ENGINE - LP COMPRESSOR - TO ANNOUNCE THE NEW BIFURCATION BOX COVER - CATEGORY CODE 7 -
MOD.ENG-72-0245

V2500-ENG-72-0245

SERVICE BULLETIN

Installation of the Bifurcation Box Cover
Fig.1

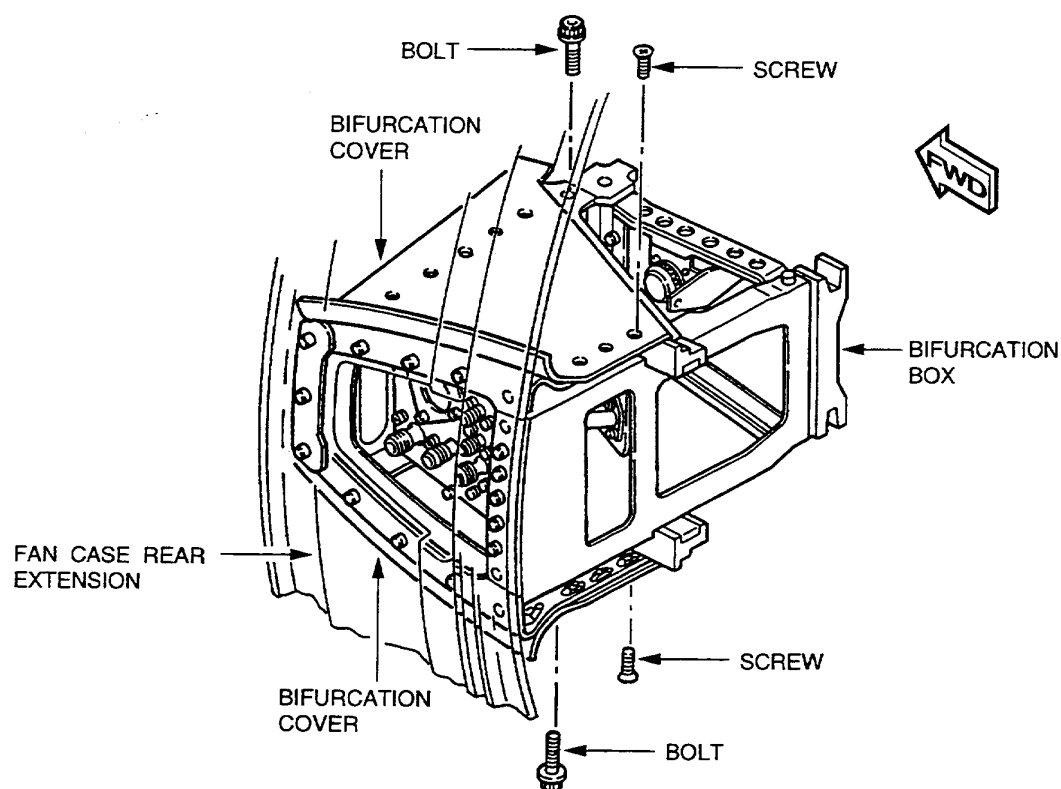
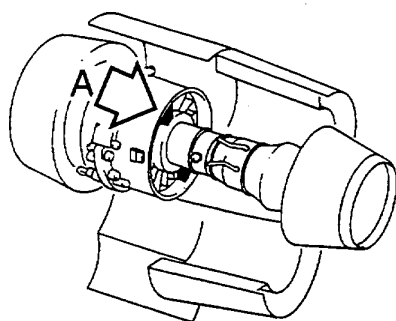
(1) This changes introduced by this Bulletin are as follows:

(a) To change the skin material of the bifurcation box cover from stainless steel to aluminium alloy.

(b) Engine weight will be decreased 3.5 lb. (1,59 kg).

- (1) Clean the mating surfaces of the new Bifurcation Box Covers and securing screws with CoMat 01-076 cleaning fluid and CoMat 02-099 lint free cloth.
- (2) Apply CoMat 07-070 zinc chromate primer to the mating surfaces of the new Bifurcation Box Covers and securing screws.
- (3) Install the new Bifurcation Box Covers by the instructions given in reference (1), Chapter/Section 72-00-32, Installation-01, Config-1 or Config-2.
